777

Service Bulletin

Number: 777-53A0075
Original Issue: January 14, 2015
Revision 1: December 14, 2015
ATA System: 5380

SUBJECT: FUSELAGE - Section 48 - Station 2370 Pivot Bulkhead Forward Outer Chord -
Inspection and Repair

FIGURE 5: LEFT SIDE - STA 2370 SKIN PANEL INSTALLATION (SHEET 1 OF 5)

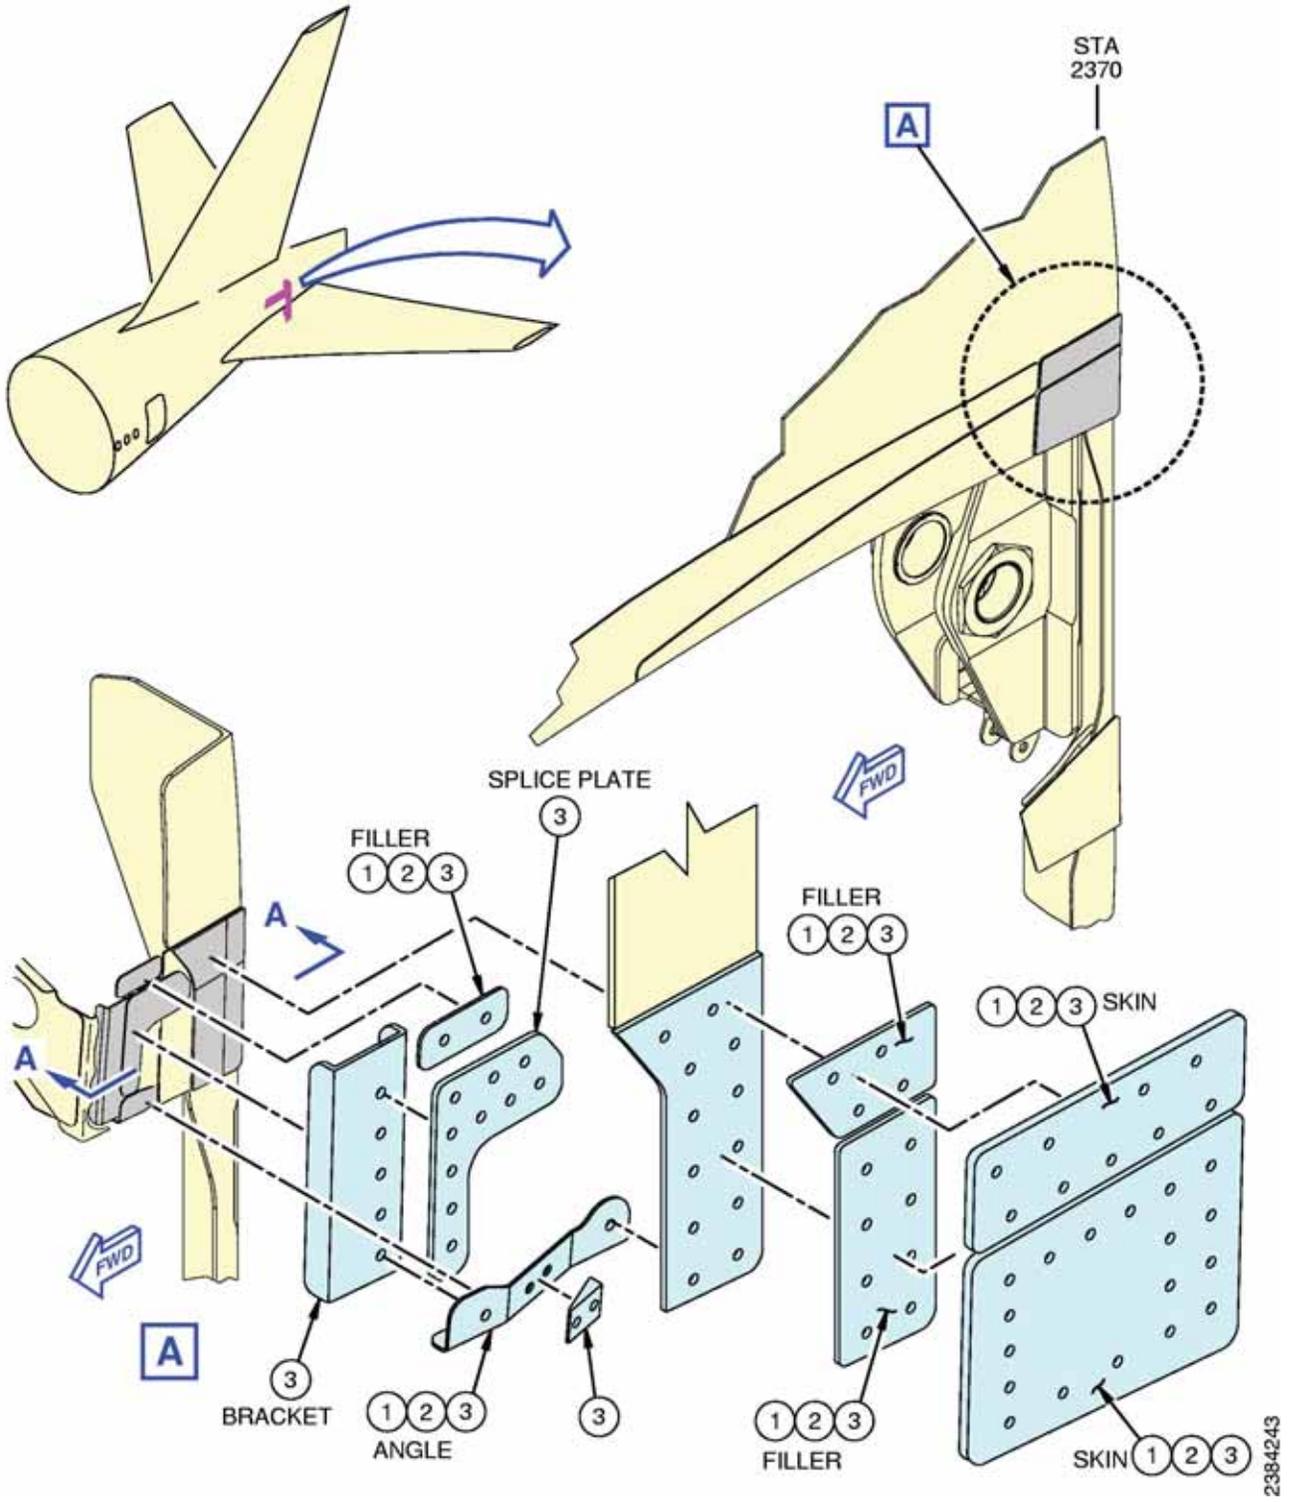
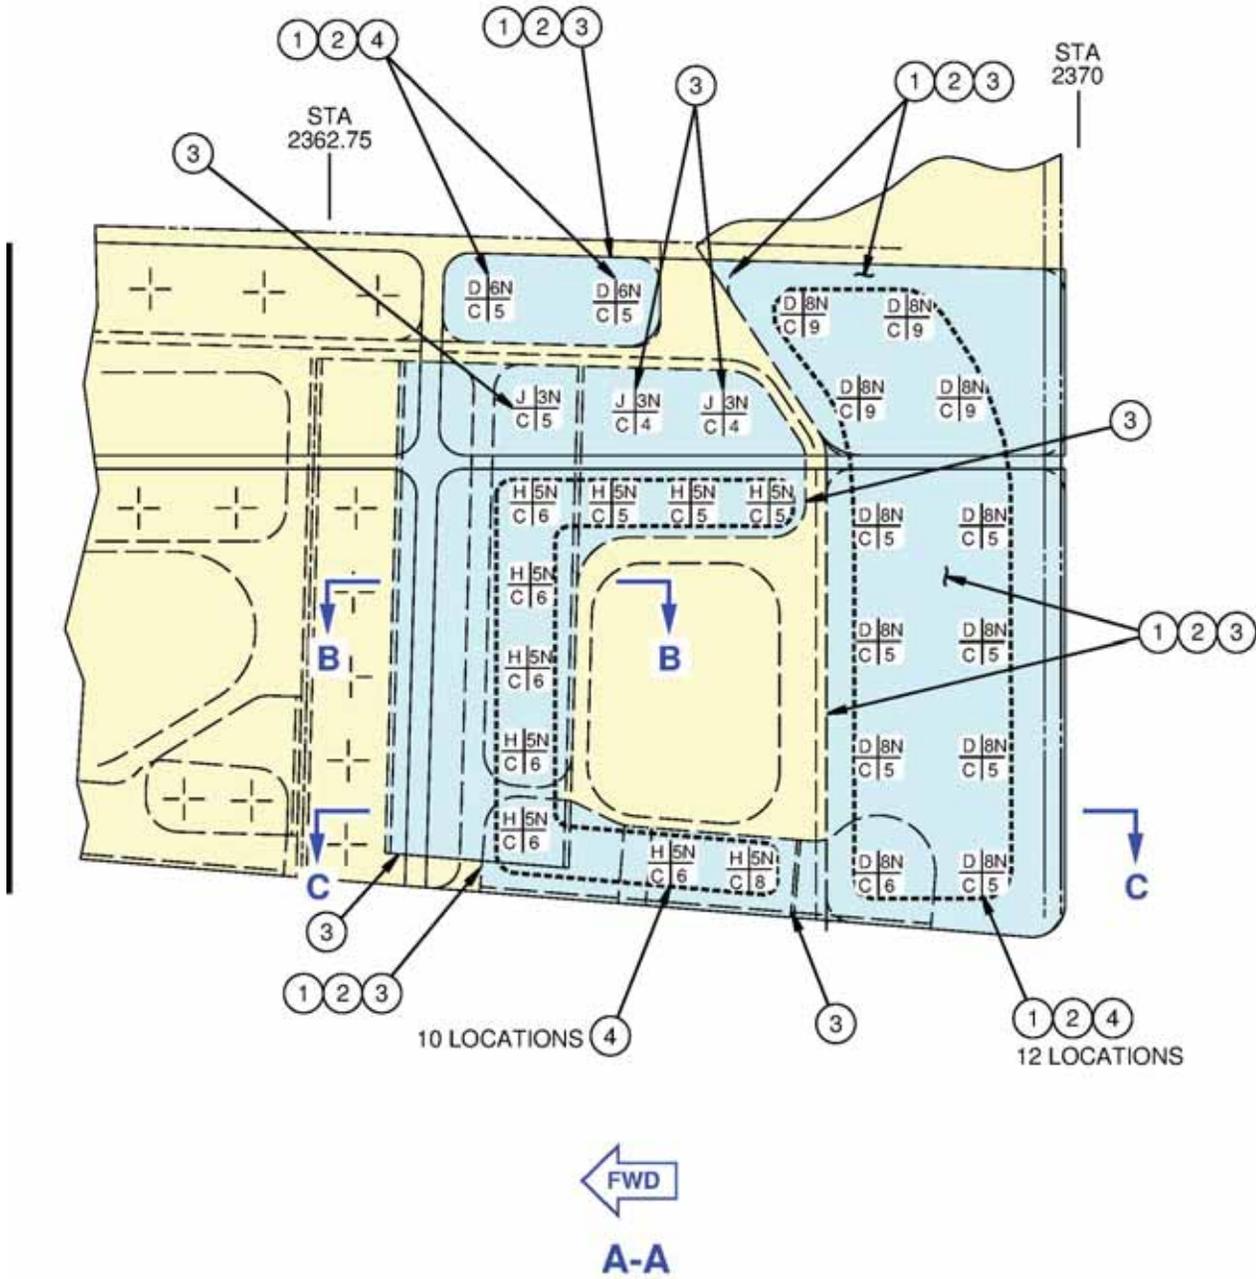
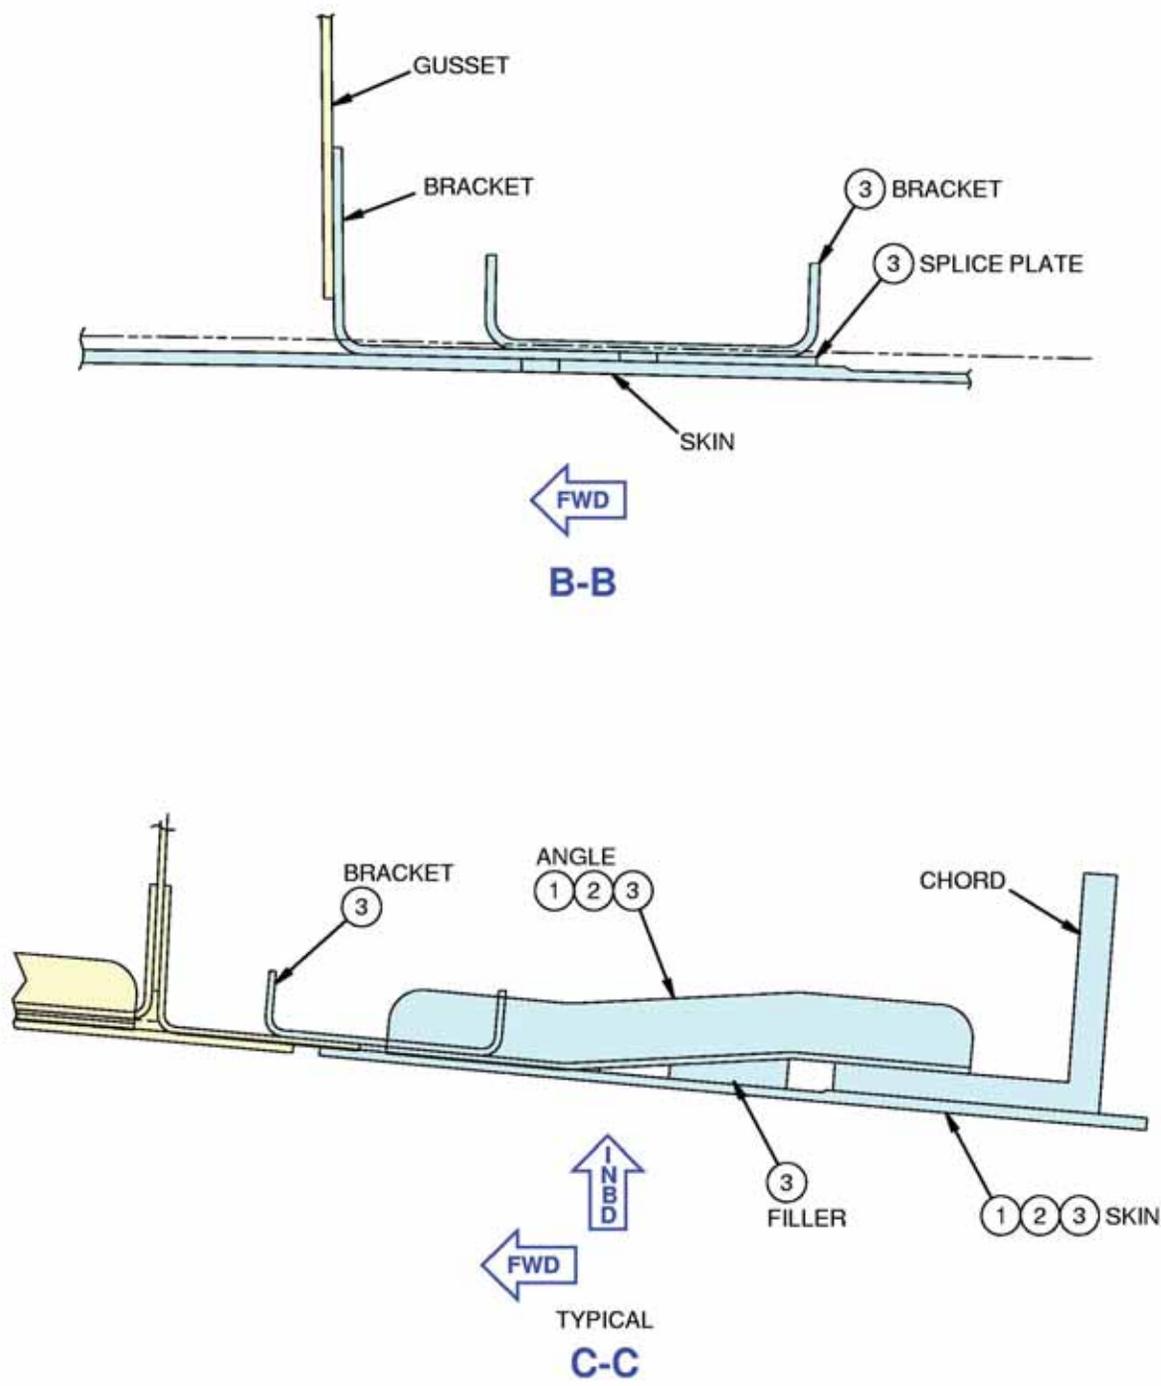
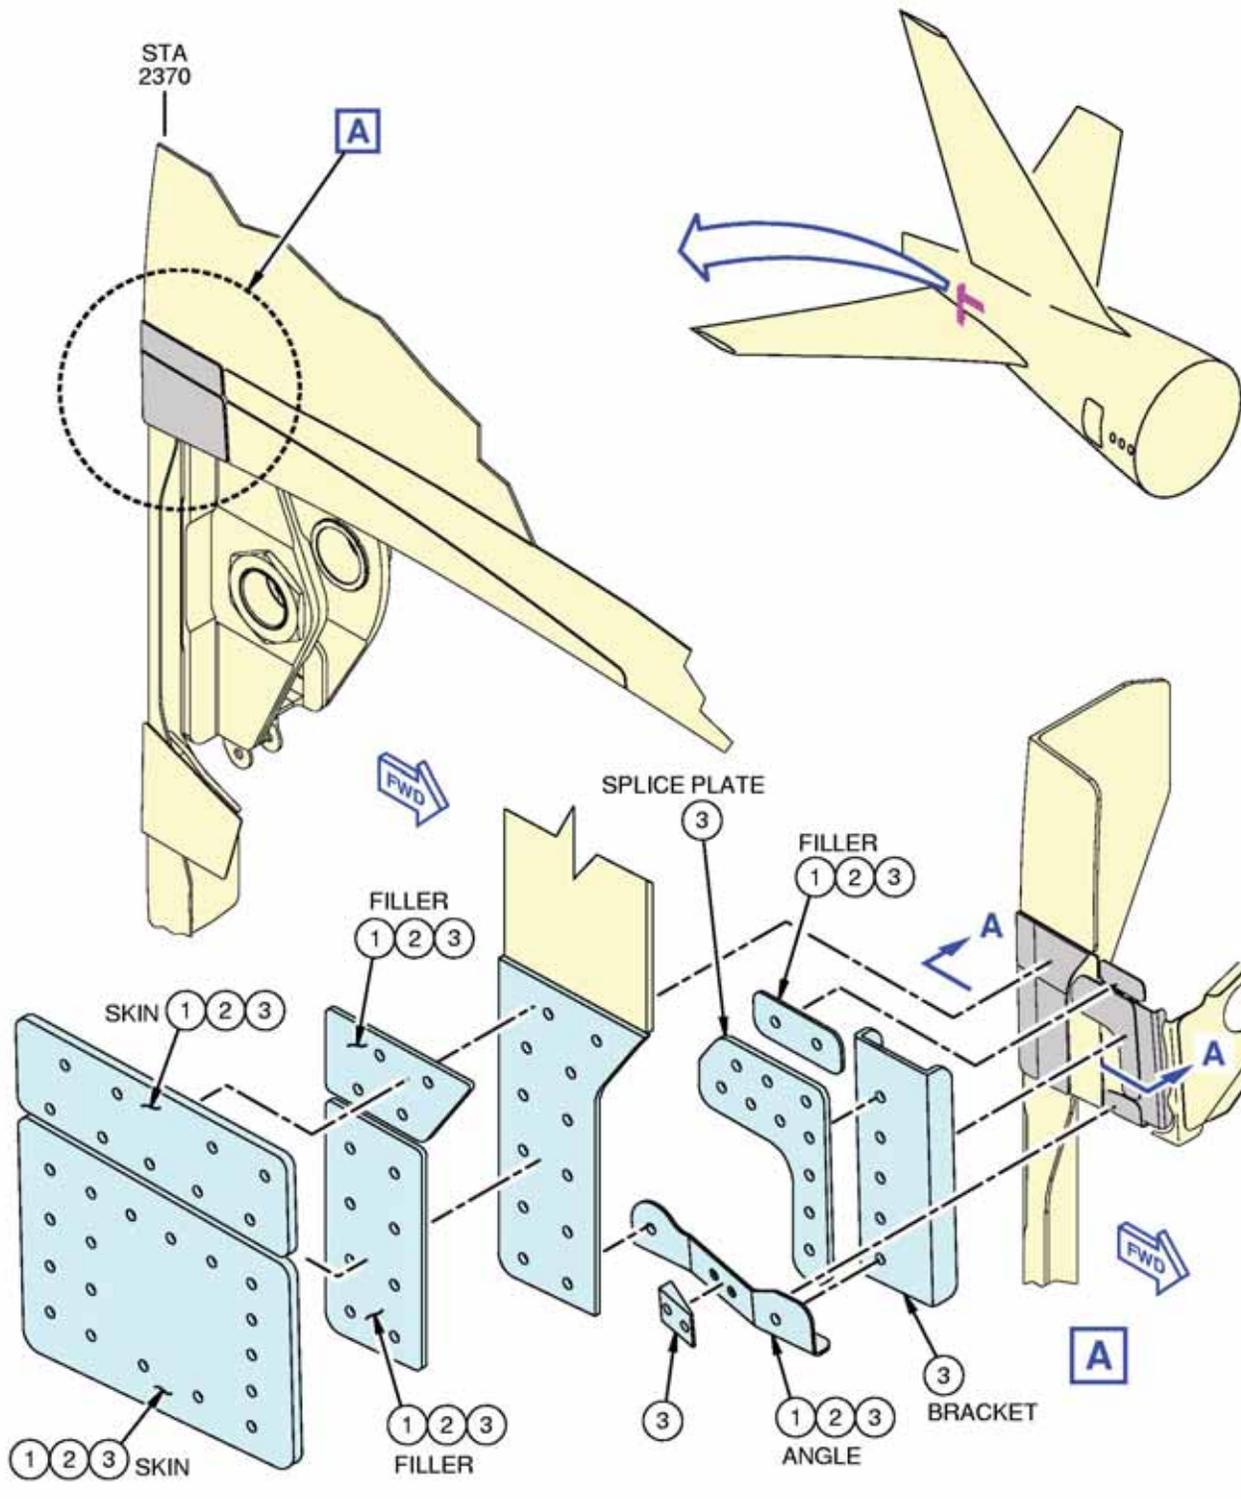
18. In Paragraph 3.B., Work Instructions, revised the work instructions.
19. In Figure 5 and Figure 6, revised the illustrations and the fastener code table.
